## SNPP BRIEFING NOTE

<b>APPLICATION NUMBER:</b>	DA2023/0976
<b>PROPERTY ADDRESS:</b>	20-22 Macpherson Street, Warriewood
<b>PROPOSAL:</b>	Demolition works, civil and infrastructure works, subdivision into 53 lots and one community title road, the construction of 53 dwellings and associated works.
<b>APPLICATION LODGED:</b>	19 July 2023
<b>APPLICANT:</b>	Urbis
<b>OWNER:</b>	Green Kingswood
<b>COST OF WORKS:</b>	\$35,900.000.00
<b>NOTIFICATION PERIOD:</b>	1 August 2023 to 29 August 2023
<b>NO. OF SUBMISSIONS:</b>	30
<b>DETERMINATION AUTHORITY:</b>	SNPP
<b>REASON FOR REFERRAL:</b>	Over \$30 million CIV

The proposal is shown below (with the red line representing the outer edge of the Creekline corridor):

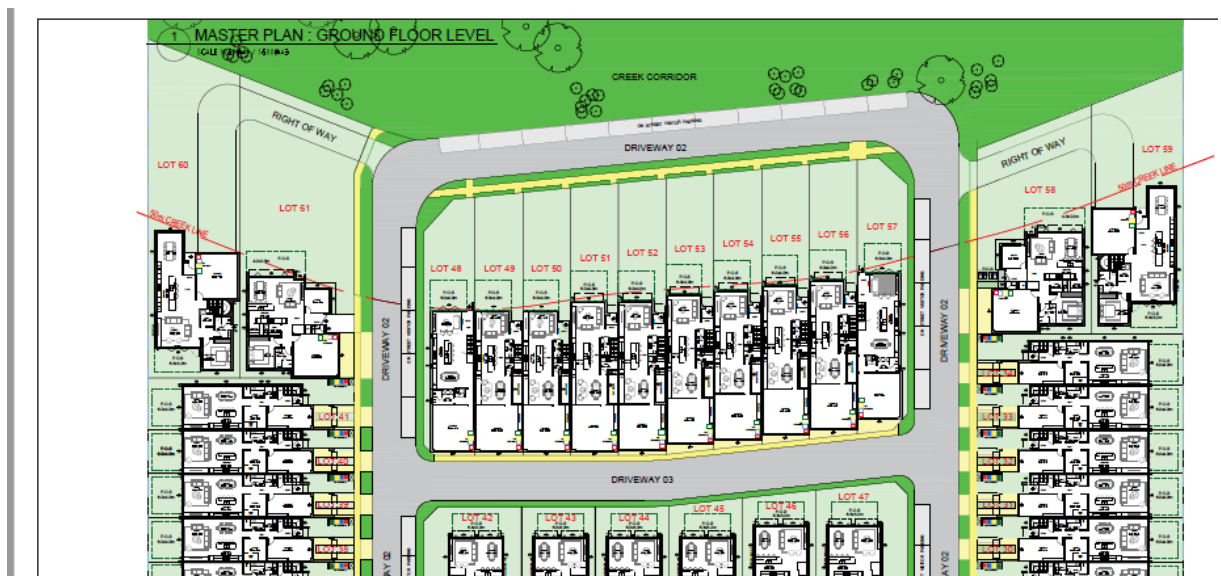
Over 80% of the outer corridor area contains features that are not permitted by the control.

This includes private lots, roads, and rights of way.

This does not provide a design that integrates well with the creek by appearing visually as a natural extension to the creek area.
